### Harman Becker Automotive, JSP14-37

Consideration of the request of Northern Equities Group for approval of Preliminary Site Plan, Woodland Permit, Wetland Permit and Stormwater Management Plan. The subject property is 16.5 acres in Section 1 of the City of Novi and located north of Thirteen Mile Road, between M-5 and Cabot Drive, in the OST, Planned Office, Service, Technology district. The applicant is proposing an 188,042 square foot facility for Harman Becker Automotive offices.

**TO:** BARBARA MCBETH; COMMUNITY DEVELOPMENT  
**FROM:** BRIAN COBURN, P.E.; ENGINEERING SENIOR MANAGER *BTC*  
**SUBJECT:** JSP14-0037 HARMAN BECKER PRELIMINARY SITE PLAN UPDATES  
**DATE:** AUGUST 7, 2014

Sketch included in motion packet for the sidewalk variance

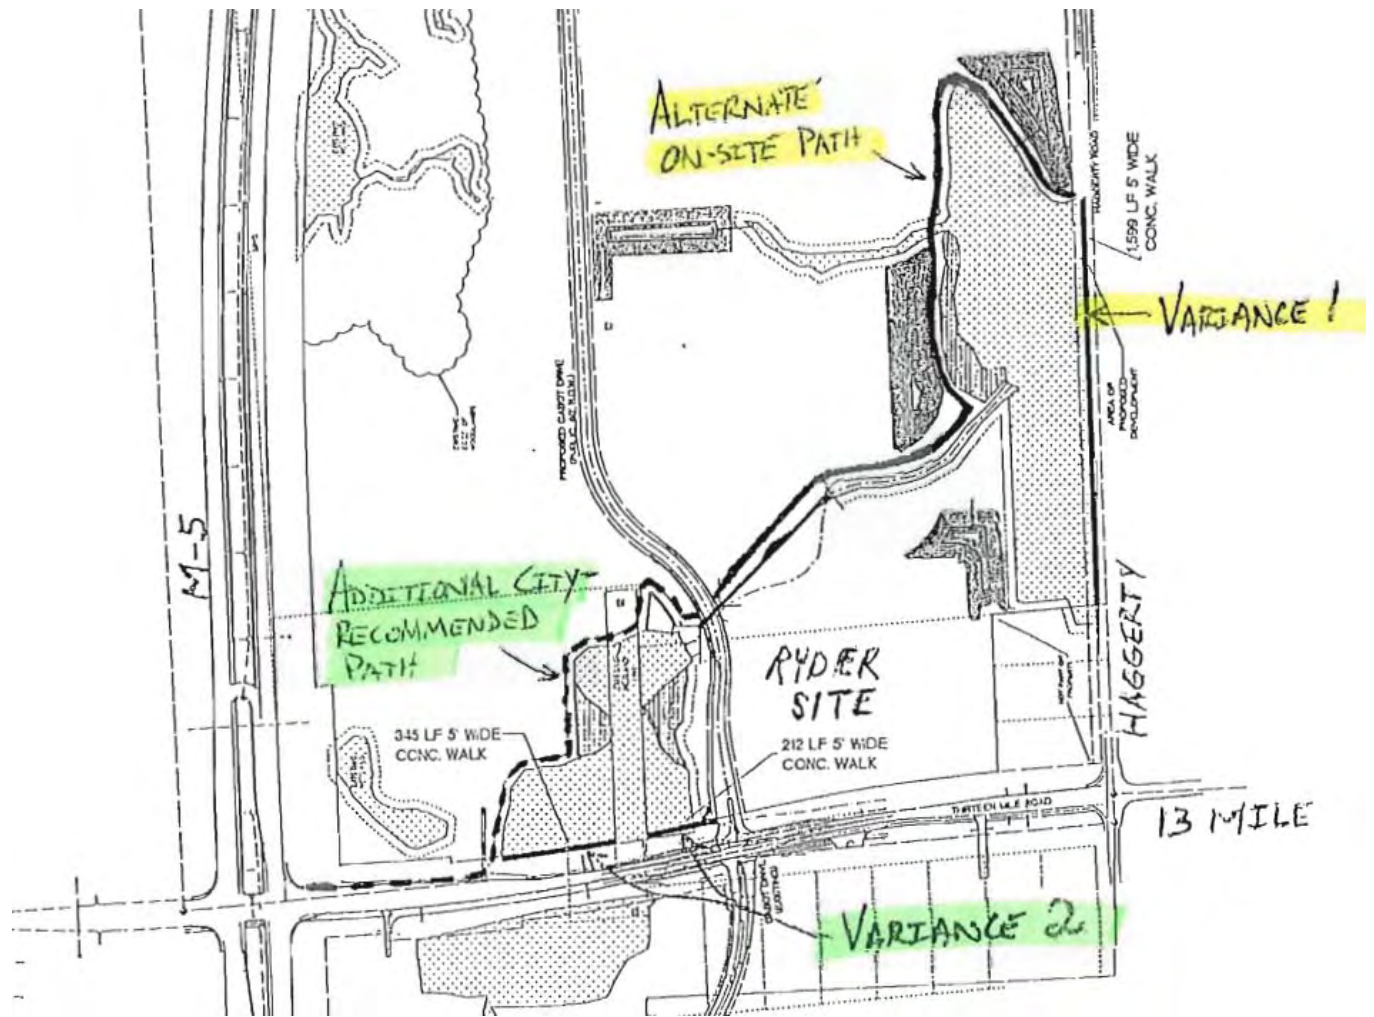
The applicant received a variance from City Council on October 8, 2007 to not construct 550 feet of pathway along 13 Mile Road between Cabot Drive to just east of the proposed Harman Becker frontage on 13 Mile Road. The remaining frontage along 13 Mile from Harman Becker to M-5 was not part of the variance that was granted and must be constructed. Additionally, the City Council motion required construction of an 8-foot wide, asphalt pathway for use by the public between Cabot Drive and 13 Mile. The attached figure was included in the City Council motion packet and demonstrates the alignment that was considered at that time. The revised plan P-2.0D (attached) shows a sidewalk that indirectly connects Cabot with 13 Mile (some segments are 7-foot wide and some are 5-foot wide). We do not believe that this proposed alignment meets the intent of the City Council motion and would not approve this plan as provided. However, **if the applicant provides a stub to the west property line along the 13 Mile frontage (as required by ordinance) AND provides an 8-foot wide pathway along the easterly property line to provide a direct connection between 13 Mile Road and Cabot Drive (as shown on the attached sketch), we would be able to recommend approval.** The applicant should address the timing for construction of the remaining portion of the 13 Mile sidewalk between this site and M-5.

SHEET NO.  
**D-1**  
 PROJECT NO.  
 06-0335

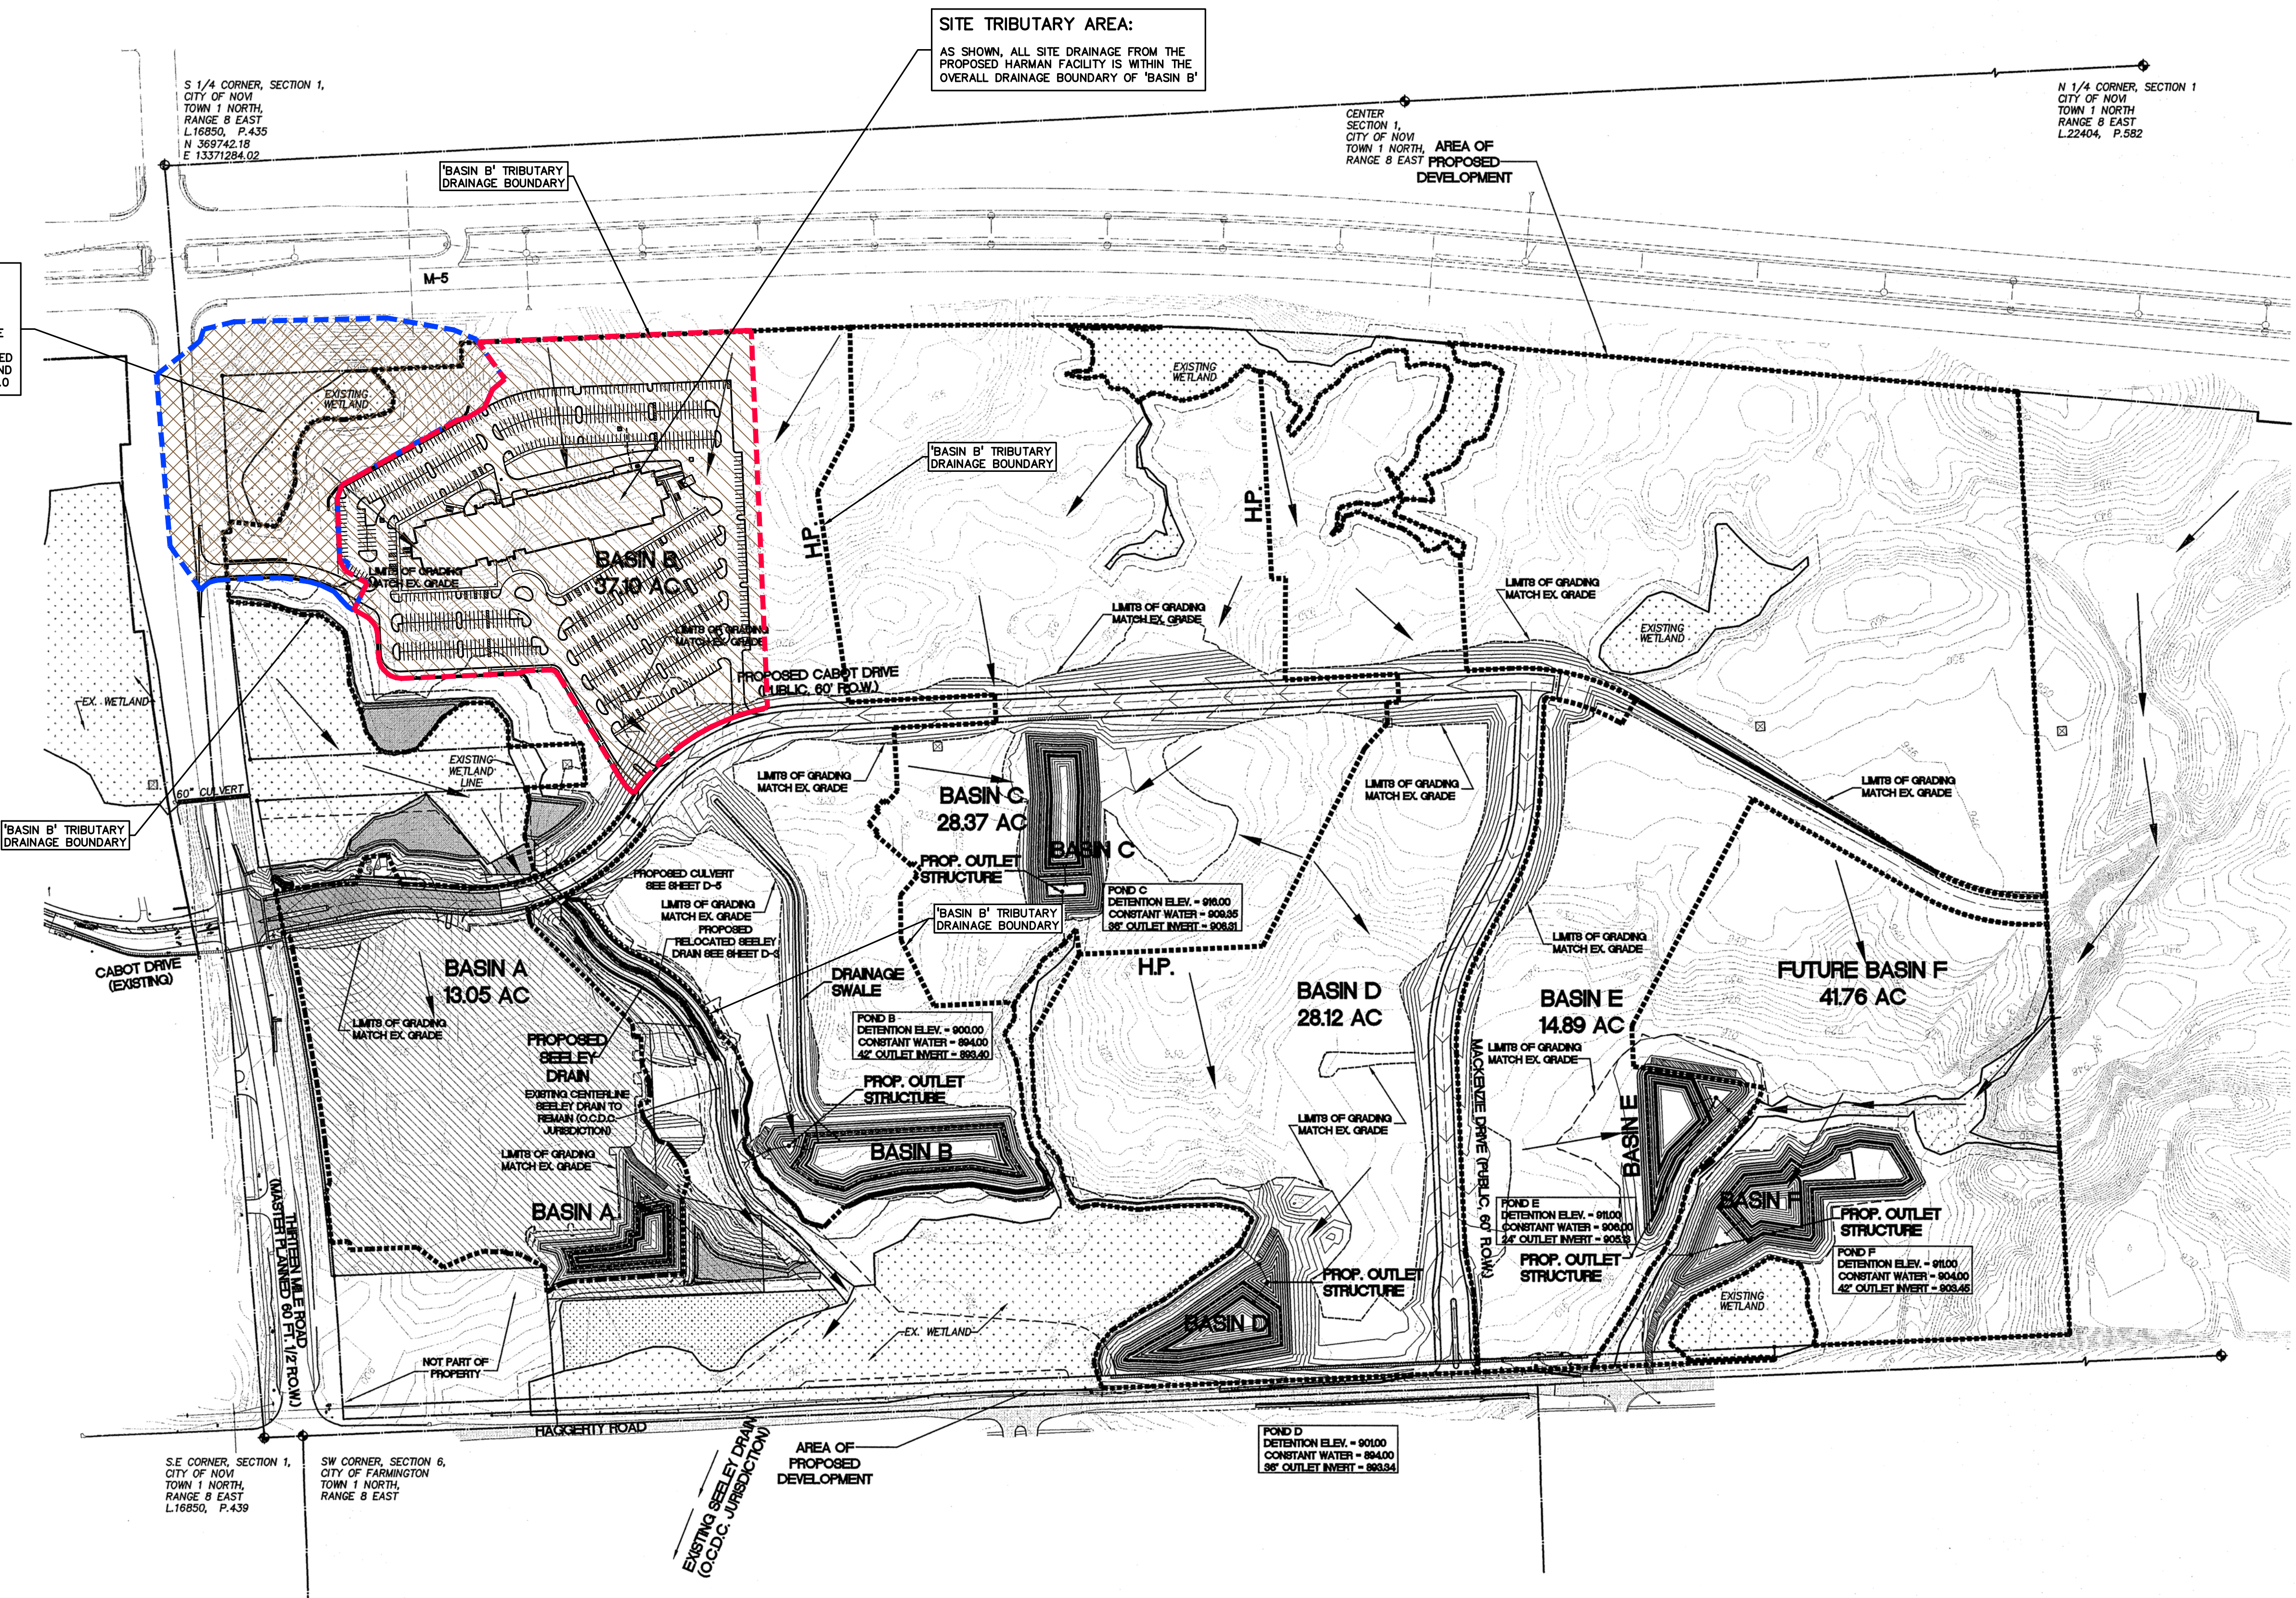
The applicant has provided revised plan sheet D-1 showing the proposed site plan on the drainage area plan for the entire Haggerty Corridor Corporate Park (attached). **This updated plan shows that the applicant has complied with this requirement.**

# EXHIBIT A HARMAN-BECKER AUTOMOTIVE LANDSCAPE – KEY AND FACT SHEET

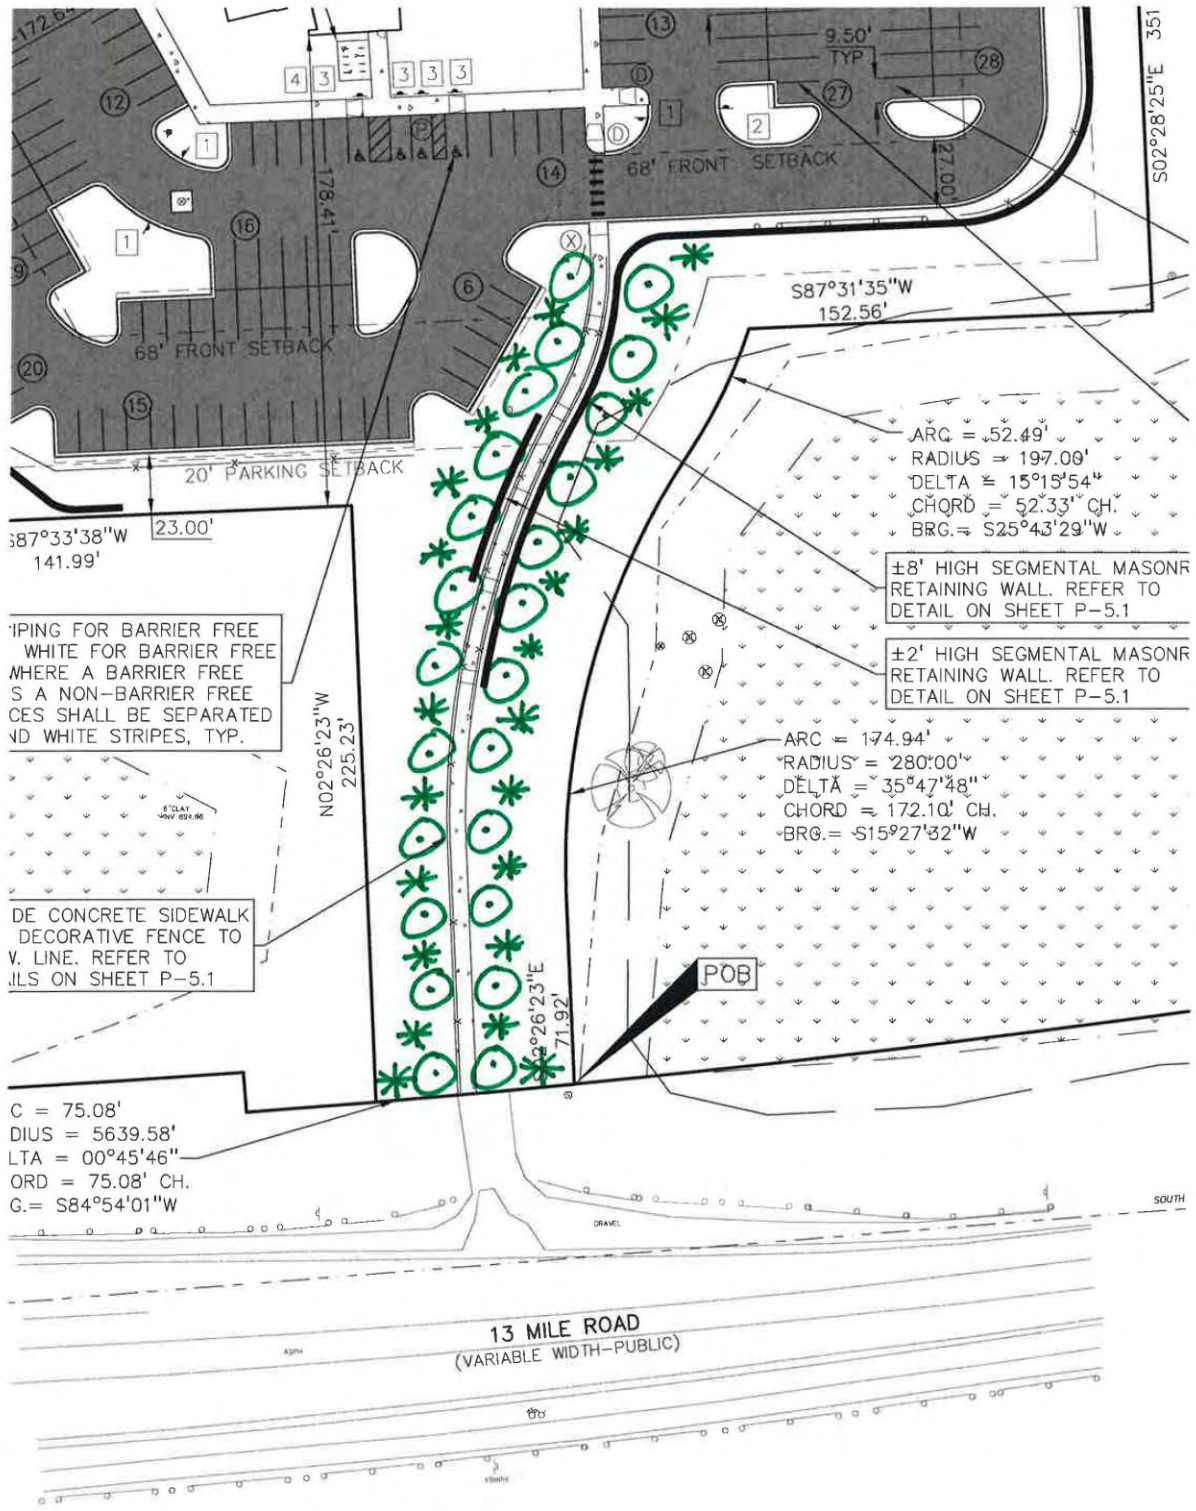
4. Overhead doors: Eight overhead doors shown on the west side of the building, which are proposed to be screened from view from M-5 by a three-foot tall landscaped berm. **The applicant is asked to provide more detail about the purpose and appearance of these doors with the response letter and on the submitted façade board.**

- Landbanked parking will be re-labeled "Phase II";
- Loading space screening will be further detailed;
- The lab area overhead doors will be sufficiently screened.  
Please see attached for more detail about the types of plantings that will be used. The doors are for car labs which

**TO BE PLACED ALONG WEST BERM AND M-5**
